VILLAGE OF ANTIOCH

ORDINANCE NO. 12-02-01

AN ORDINANCE APPROVING A PRELIMINARY PLAT OF SUBDIVISION ON THE NORTH SIDE OF ILLINOIS ROUTE 173, IMMEDIATELY EAST OF ILLINOIS ROUTE 83(FILE NO. PZB 11-07)

To: Dustin Nilsen
From: Lee Shannon, III
CC: John Nixon, Jim Keim, Dennis Heimbrodt
Date: November 29, 2011
Re: Plan Review – Plat Approval for Subdivision – IL Route 173 & IL Route 83 – Walgreens – Site Plans Only

A Aerial Photo

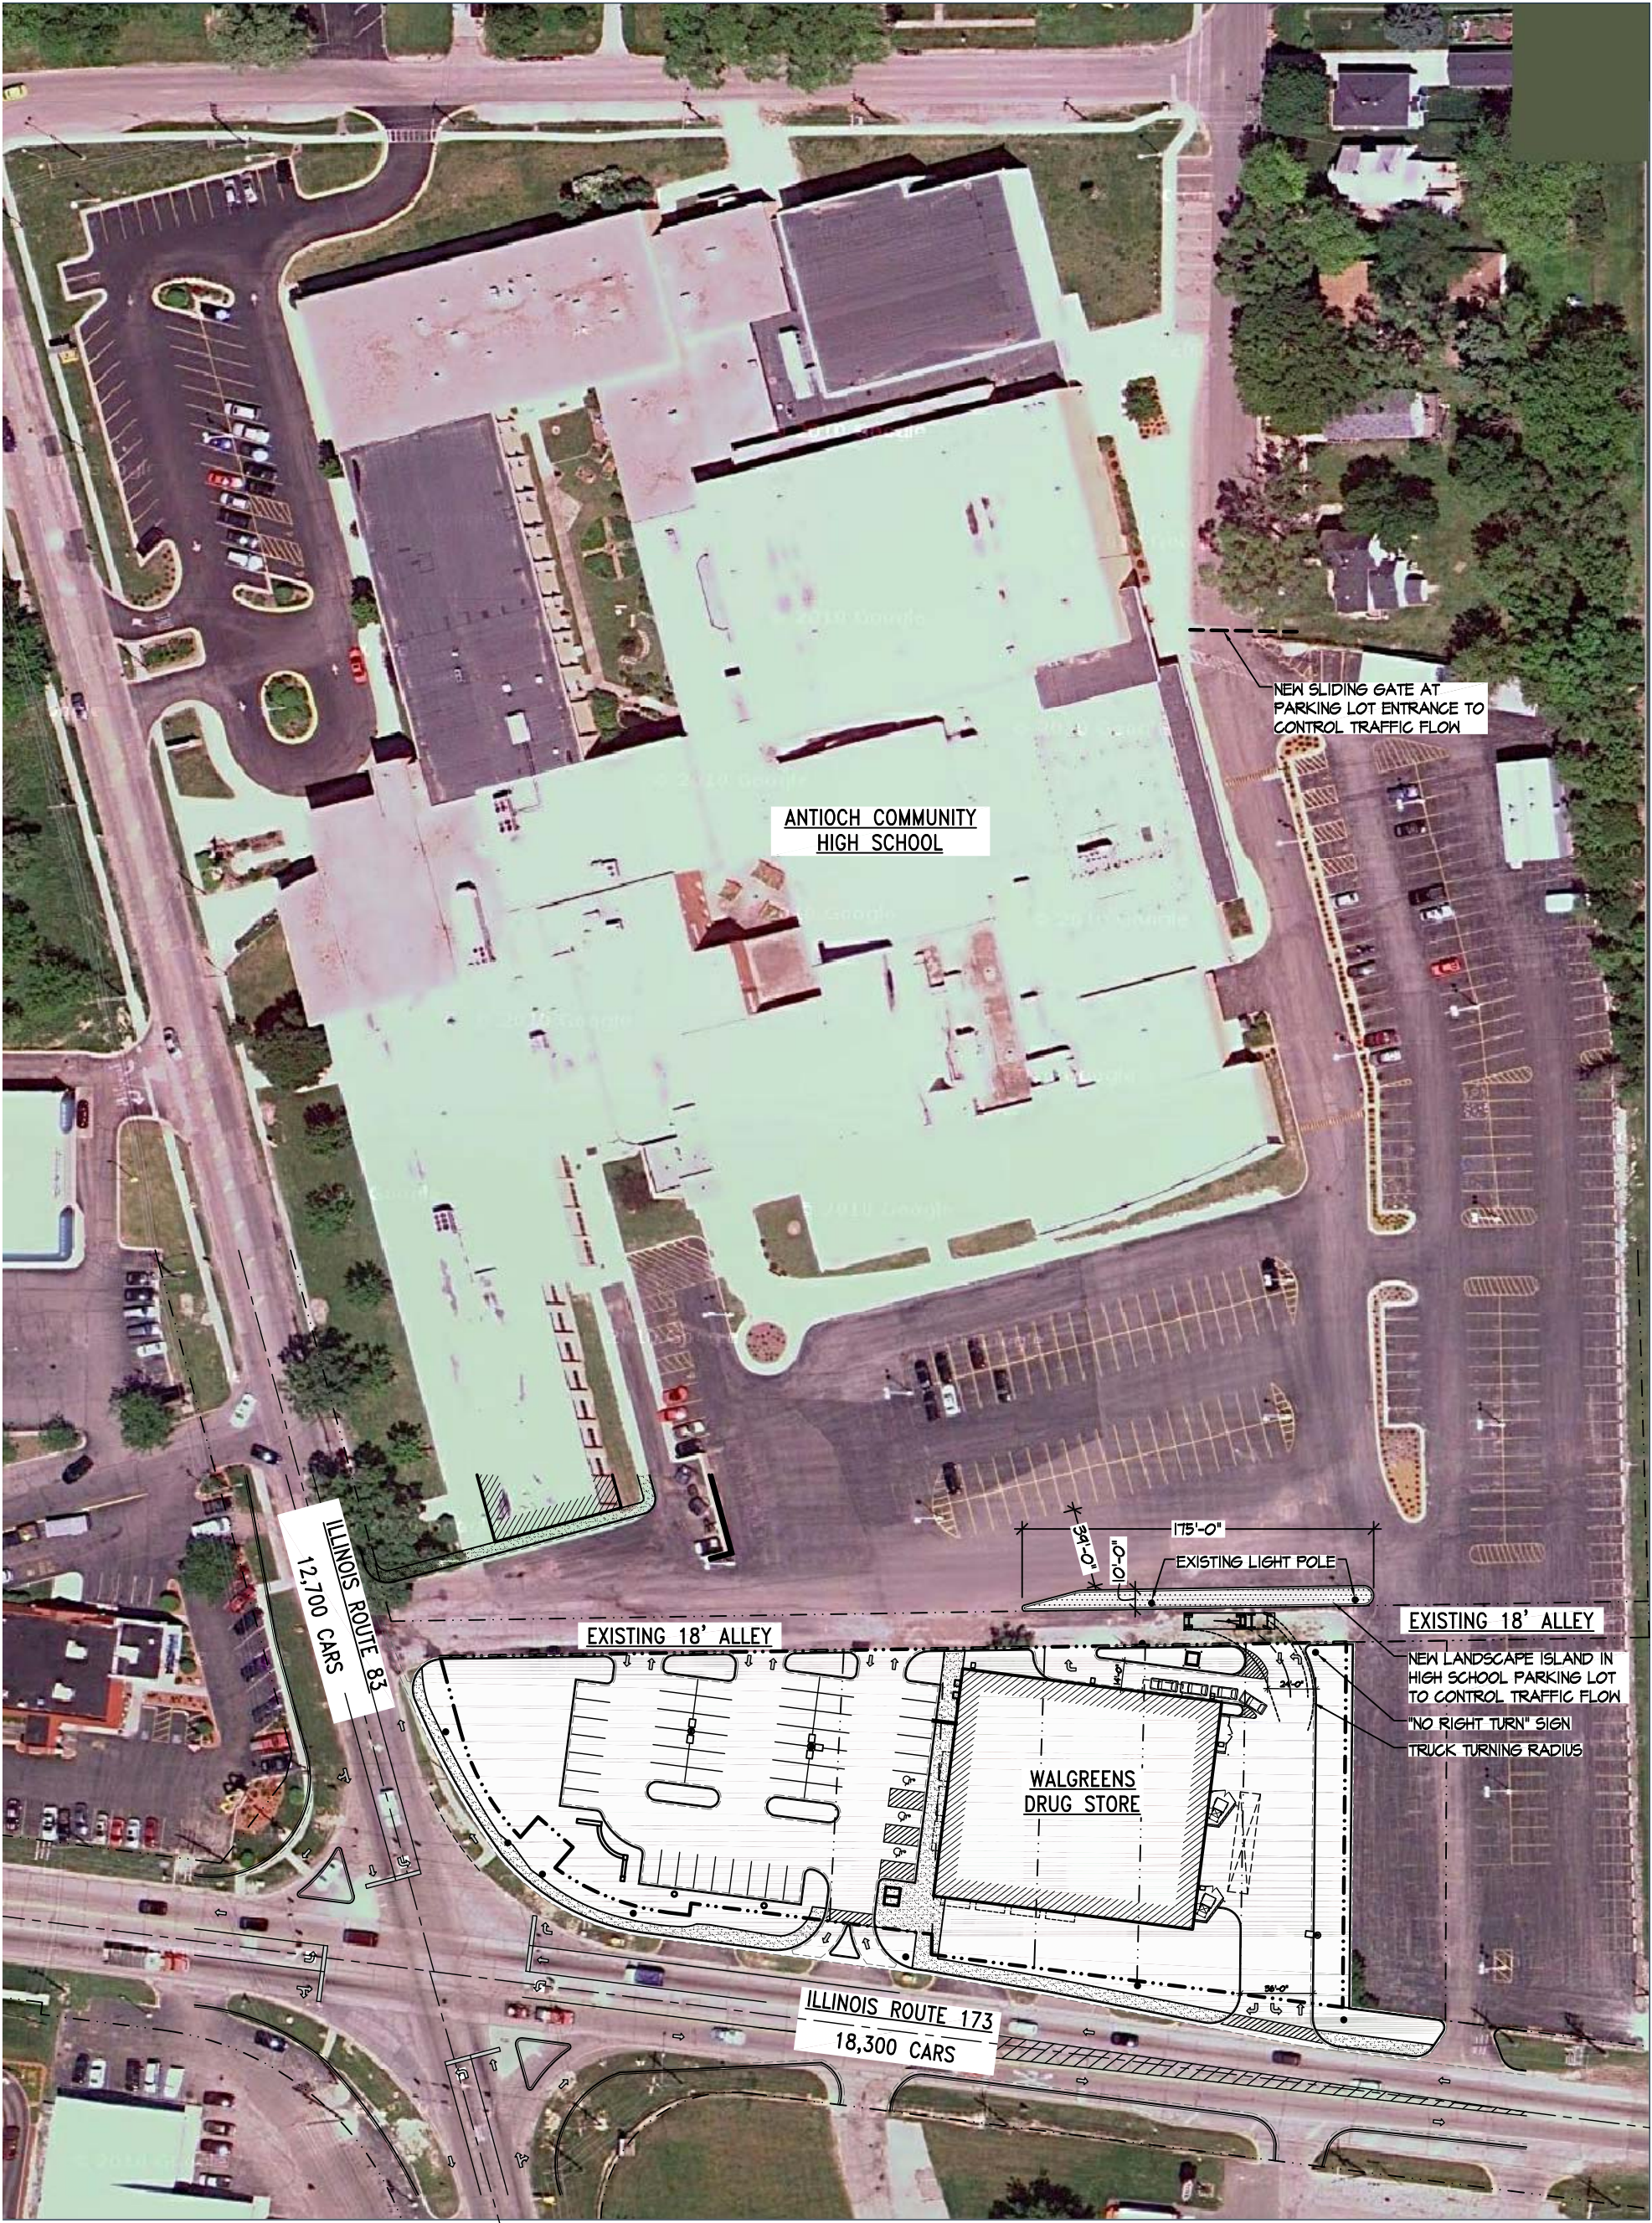
The District would like a median/barrier constructed, preferably 1-2 feet tall and a few feet wide that will contain plant material and be aesthetically pleasing. This barrier will delineate school traffic from Walgreens traffic and will allow the District to better control any traffic that may enter its property. It is desirable for this barrier to curve, in such a way, that it will block traffic entering district property, near the drive thru, and interfering with student foot traffic. (see attachment)

In the event it is not possible to have such a barrier cross the alleyway, the District would like a low profile impediment that would provide traffic control while still allowing any emergency vehicles to utilize the alleyway appropriately. This impediment would only replace the barrier section that crosses the alleyway. Along with the low profile barrier, the District would like signage directing Walgreens traffic to remain on Walgreens property.

It is understood that any barriers will be constructed on CHSD 117 property. Further, the District would like Walgreens to construct all barriers, at no cost to the District, during the construction of its new store. A drawing is included that illustrates the District's request.

This is an existing condition independent on the proposed Walgreens store and is unlikely to increase as a result. If desired, we recommend as a possible solution the installation of a gate to be located along the east side of the high school south of Bishop that will prevent traffic from accessing the school lot during the school day. Assuming the Village's emergency services finds this acceptable, Centrum would be willing to install this gate as shown on the attached site plan exhibit.

In order to address this concern, the attached site plan shows an island barrier separating the drive through internal access drives from the school's parking lot thus providing the desired delineation while providing for efficient and adequate vehicular access from IL 83 for both the school and Walgreens. In addition, the access drive along the east Walgreens property line has been configured and a "No Right Turn" sign will be added in order to discourage right turns.

UTILITY CROSSINGS

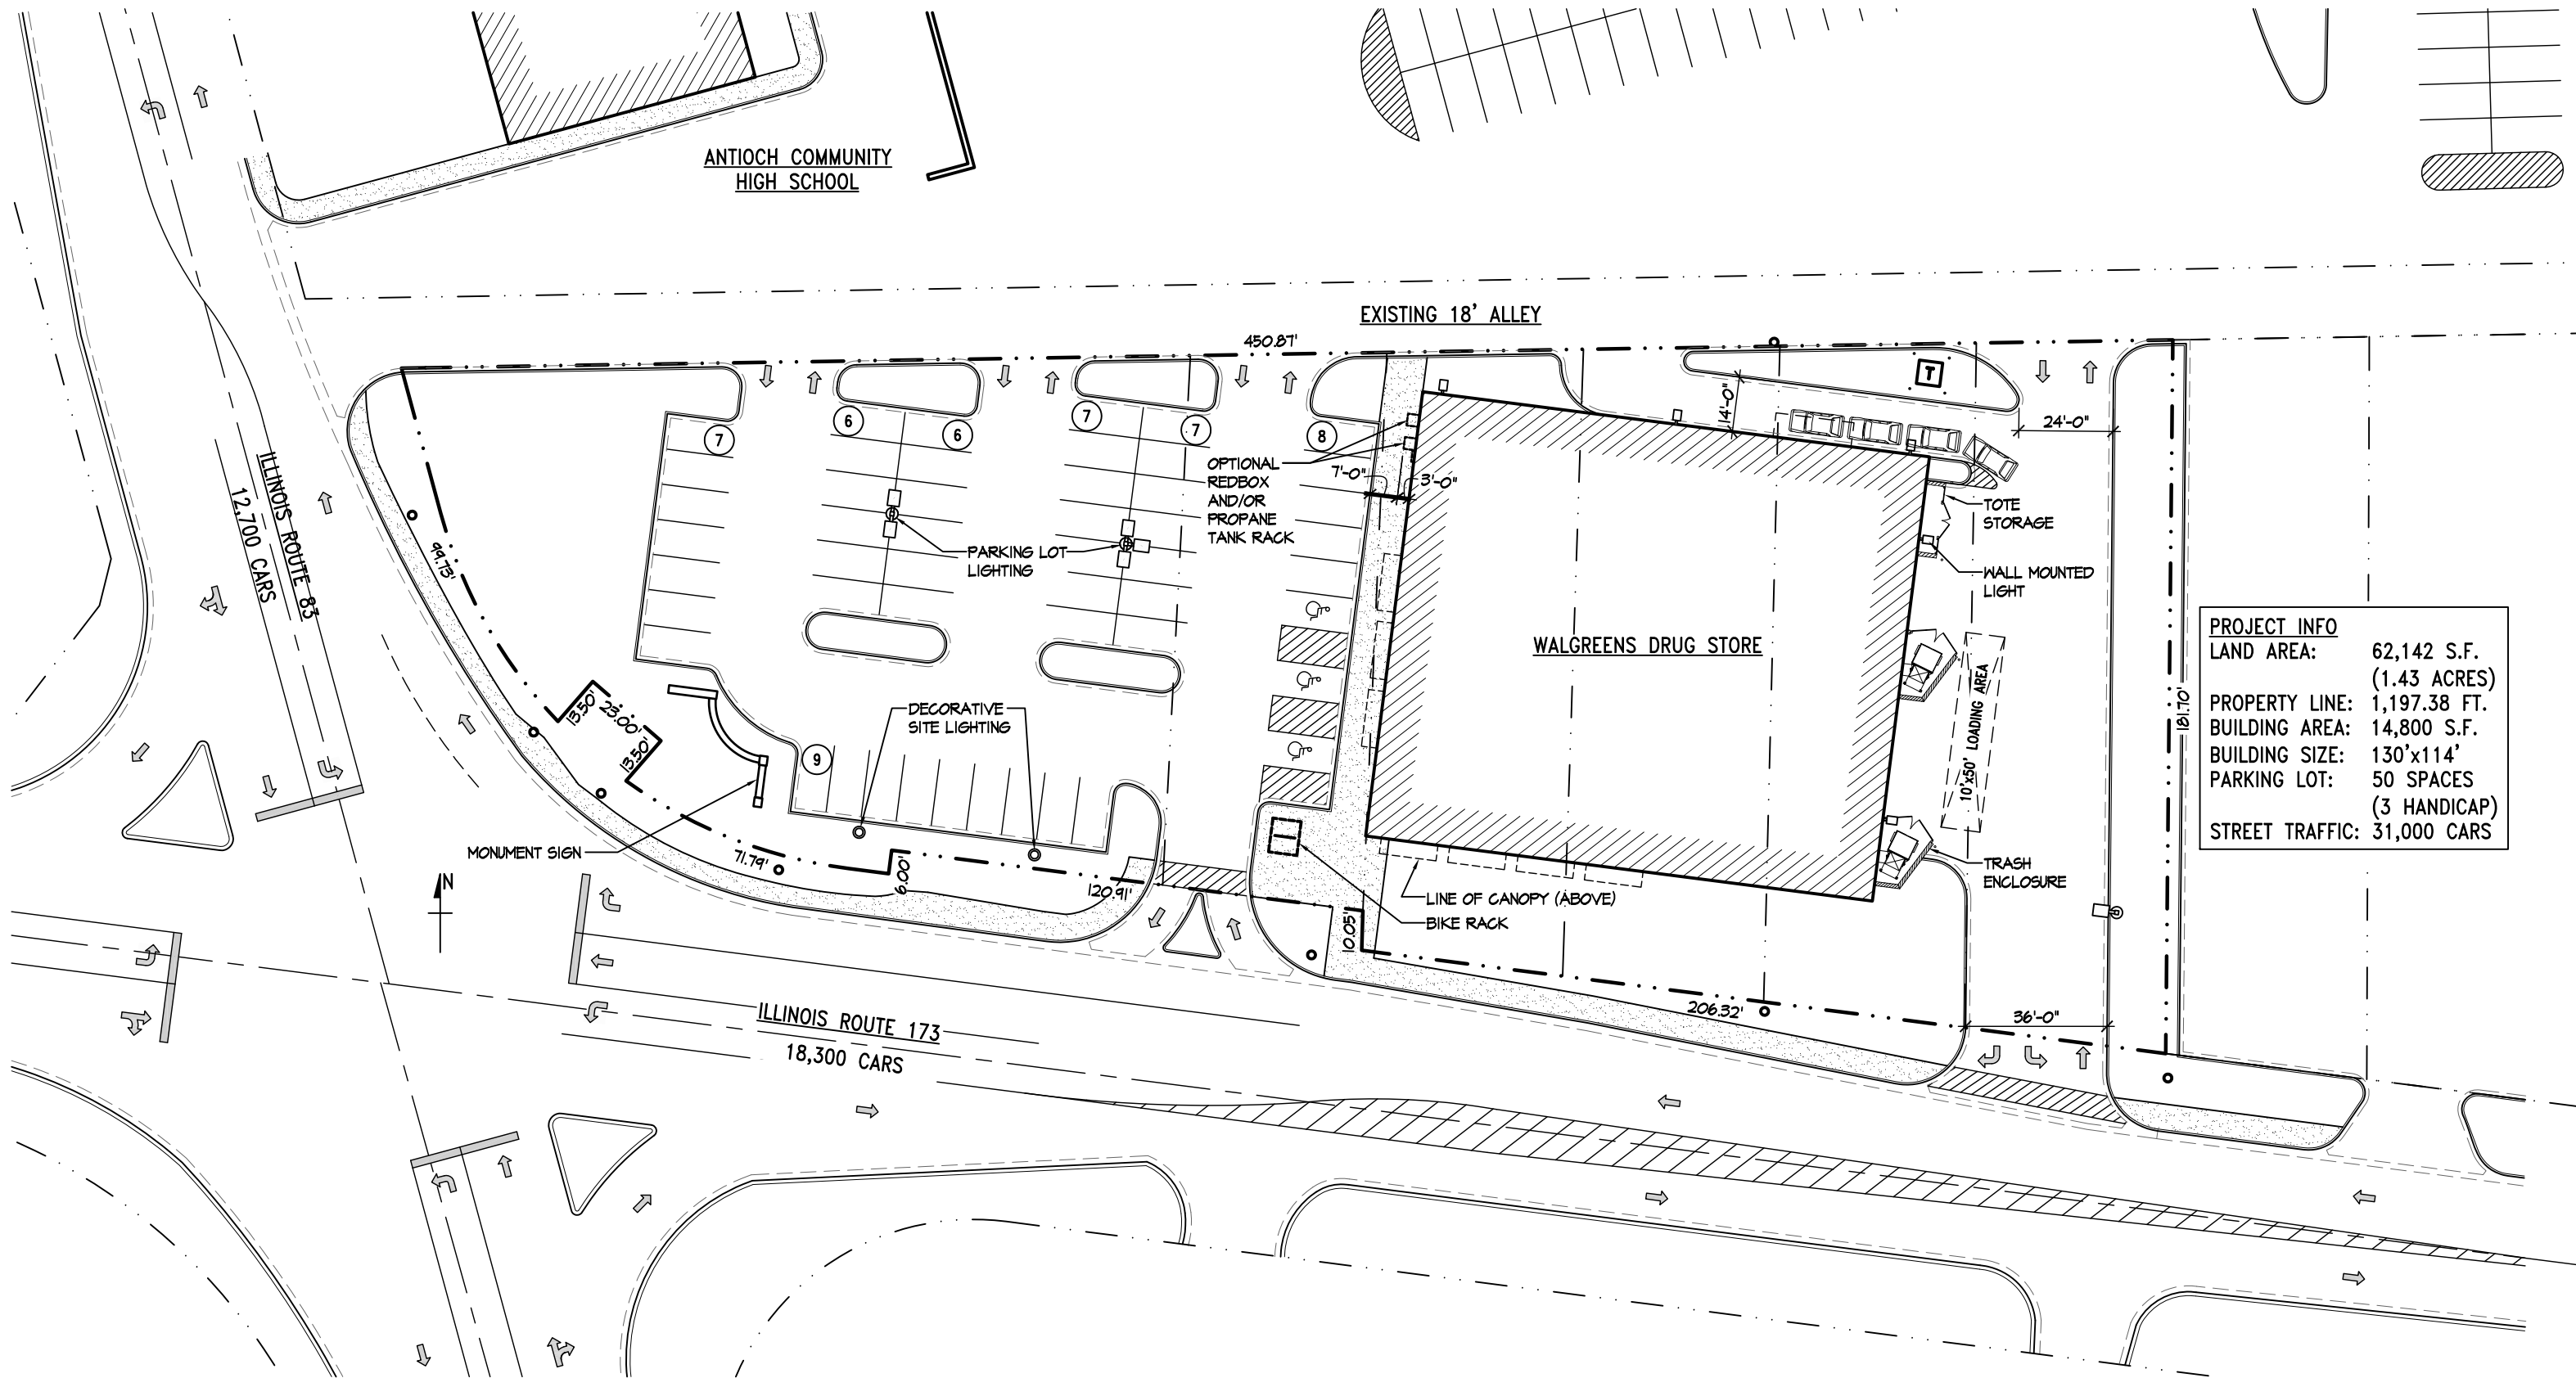
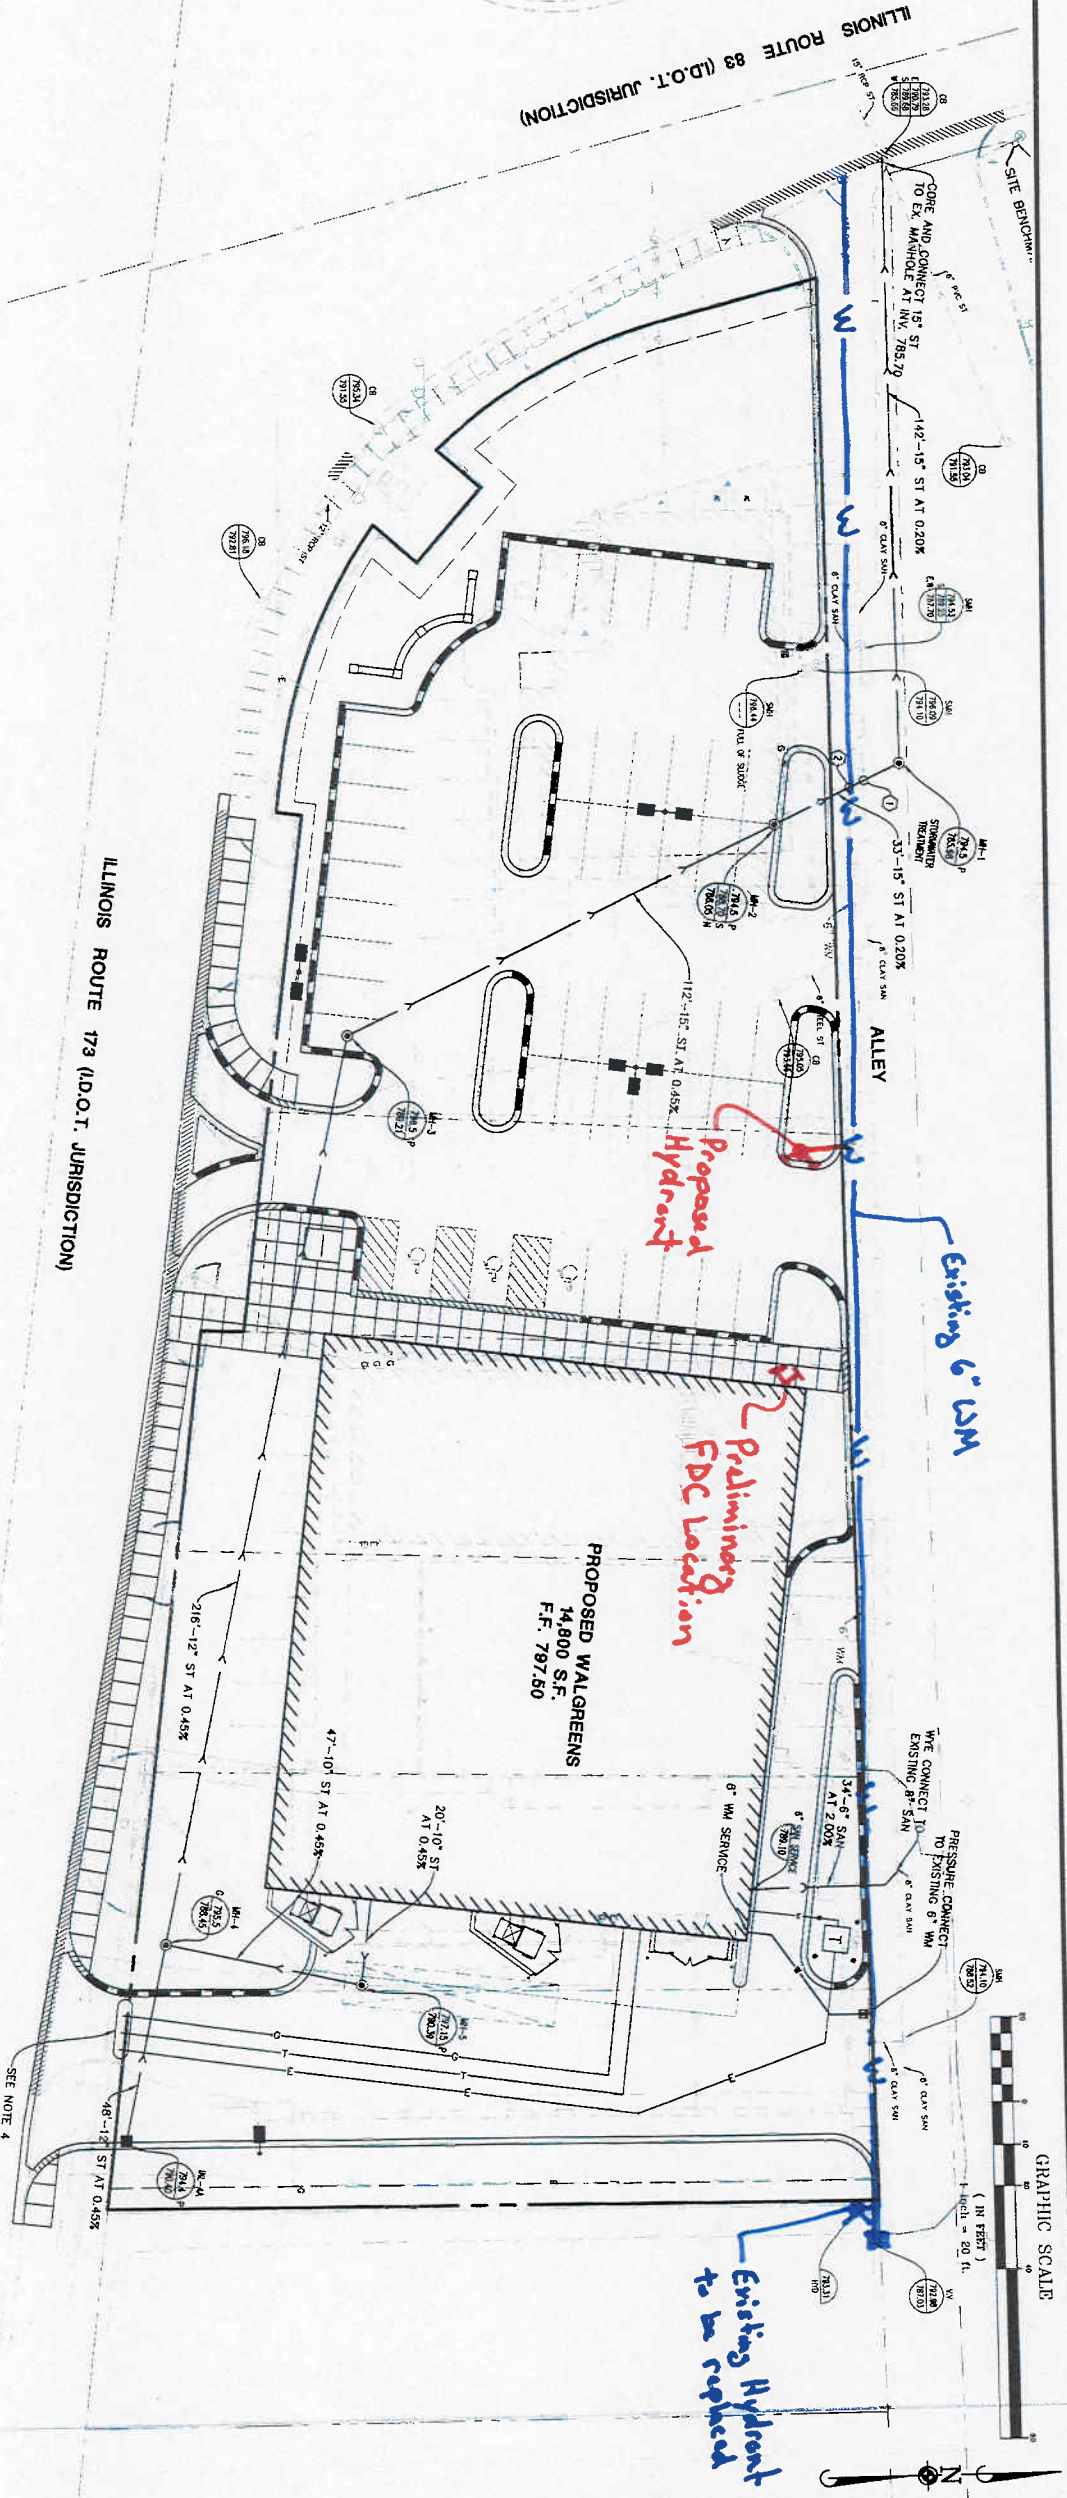
5. In Item #1, discussion centered on the 6" water main. On the utility plan, it appears that this 6" water main will be used as a service connection for Walgreens. The proposed size of the building is 14,800 square feet. This will require the building to have an automatic fire protection (sprinkler) system installed. There is no indication of where this system will connect to a water main or where the fire department connection will be located.

Please submit a more detailed utility plan that will show where the automatic fire protection (sprinkler) system will be tied into a water main and where the proposed fire department connection will be located.

We have enclosed a red line mark up of the preliminary utility plan to show the improvements that we are proposing to make. Our client, Centrum Properties, is proposing to replace Hydrant #17-02-03 as requested and to add the additional hydrant requested along the northern property line. As you can see in the attached calculations from the mechanical engineer the existing 6" water line will provide sufficient flow to support the sprinkler system in the proposed building. Therefore, we are seeking relief from the request to extend the existing 6" main $\pm 250'$ under IL Route 173 to connect to the 12" main south of 173 and to install an additional hydrant in the southeast corner of the property.
